BOWIE MUNICIPAL AIRPORT (0F2)
BOWIE, TEXAS
TxDOT CSJ No. 2403BOWIE
Lochner Project No. 23579

ADDENDUM NO. 2
February 5, 2026

Construct Airport Wildlife Perimeter Fence

ADDENDUM NO. 2 QUESTIONS FROM PROSPECTIVE BIDDERS

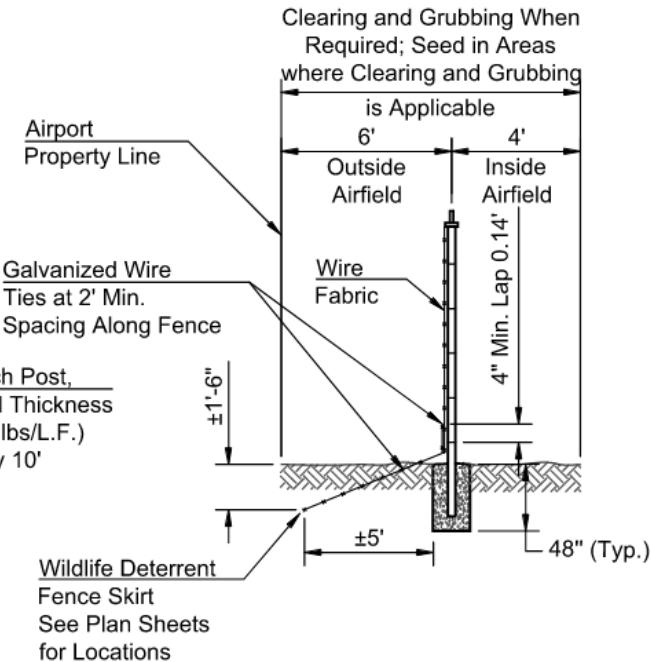
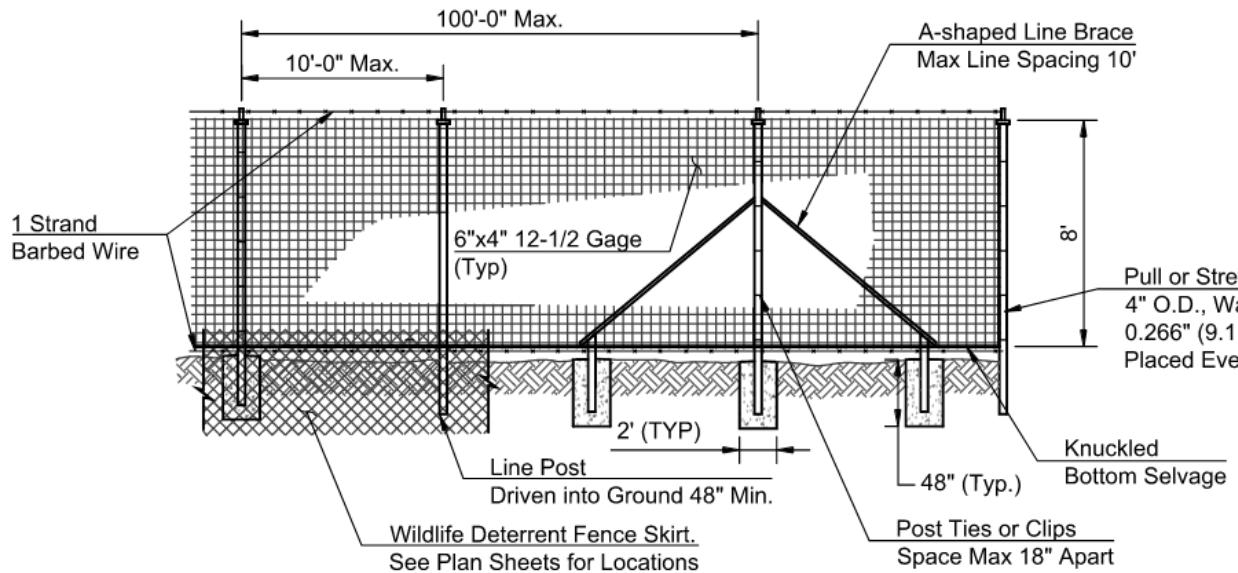
Q10: Is it permissible to move the staging area closer to the work area?

A10: No. The staging and work areas are as depicted on the plans. Access outside of the designated areas, including on airfield pavements, is not permitted.

LOW WATER CROSSING DETAIL

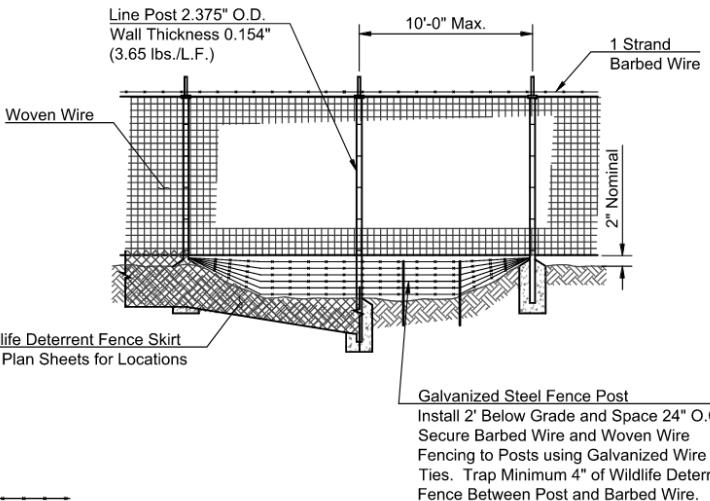
Q8: Low water crossings may not allow installation of deterrent skirts. What alternatives are acceptable?

A8: At no additional cost to the project, alternative solutions that allow logs and debris to pass without accumulating and restricting water flow may be considered, subject to proper coordination and approval by the Engineer.
